## **SCOTT PLANTATION SUBDIVISION, UNIT NINE**

The purpose of this application is to create 86 legal lots of record from two recorded legal lots of record of two subdivisions.

# DETAIL SITE PLAN

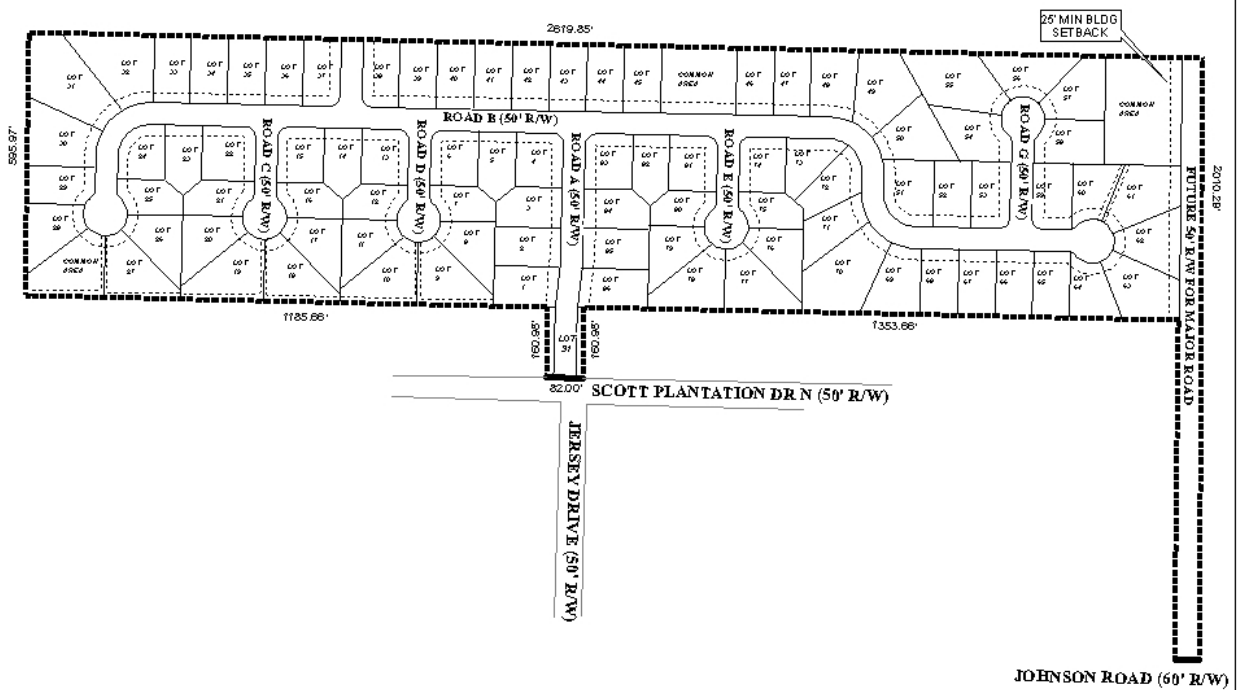
This subdivision is in reality a resubdivision of Lot 32 of Saddlebrook Subdivision, Unit Five, and Lot 31, Scott Plantation Subdivision, Unit Eight. All new lots would be on Lot 32, and Lot 31 is proposed as the only access point. Since this is proposed to be the only access, its positioning is critical for traffic flow. The lot is located on the North side of Scott Plantation Drive North, and almost directly in line with Jersey Drive East which terminates on the South side of Scott Plantation Drive North. As illustrated on the preliminary plat, the proposed right of way through the vacant lot does not align with that of Jersey Drive East, but it could be shifted East to do so. Lot 32, Scott Plantation Subdivision, Unit Eight, would then have to be incorporated into this subdivision to provide a radius at the Northeast corner of the proposed access and Scott Plantation Drive North and to provide a minimum building setback line along the new frontage for that lot. To the West, the East property line on Lot 30, Scott Plantation Subdivision, Unit Eight would suffice for the building setback line, assuming sufficient common area were placed to the East of it. As proposed, the plat makes no allowance for a minimum building setback for the two lots facing the access and indicates approximately 16' of common area between the proposed right-of-way line and the property lines. The plat should be revised to resolve this issue, preferably by the inclusion of Lot 32, Scott Plantation Subdivision, Unit Eight in this subdivision.

The plat indicates only one access stub to an adjacent parcel to the North. However, there are three adjacent parcels to the North, and the plat should be revised to provide an access through proposed Lot 56, which would create an additional stub to the undeveloped property to the North.

The proposed subdivision has several cul-de-sacs without central medians, all indicated to have 100' diameter rights-of-way. The 2003 International Fire Code requires a 120' diameter for cul-de-sacs without a central median. Therefore, the plat should be revised to indicate 120'

diameters on all cul-de-sacs with revisions to the building setback lines and lot sizes for all lots affected by the increased diameters required.

- 1) revision of the plat to align the access right-of-way via Lot 31, Scott Plantation Subdivision, Unit Eight with the right-of-way of Jersey Drive East and to provide a minimum building setback line along the access for Lot 32, Scott Plantation Subdivision, Unit Eight;
- 2) revision of the plat to provide an additional access stub to the undeveloped property to the North through proposed Lot 56; and
- 3) revision of the plat to provide 120' diameters for the rights-of-way on all cul-de-sacs with revisions to the minimum building setback lines and lot sizes for all lots affected by the increased diameters required.
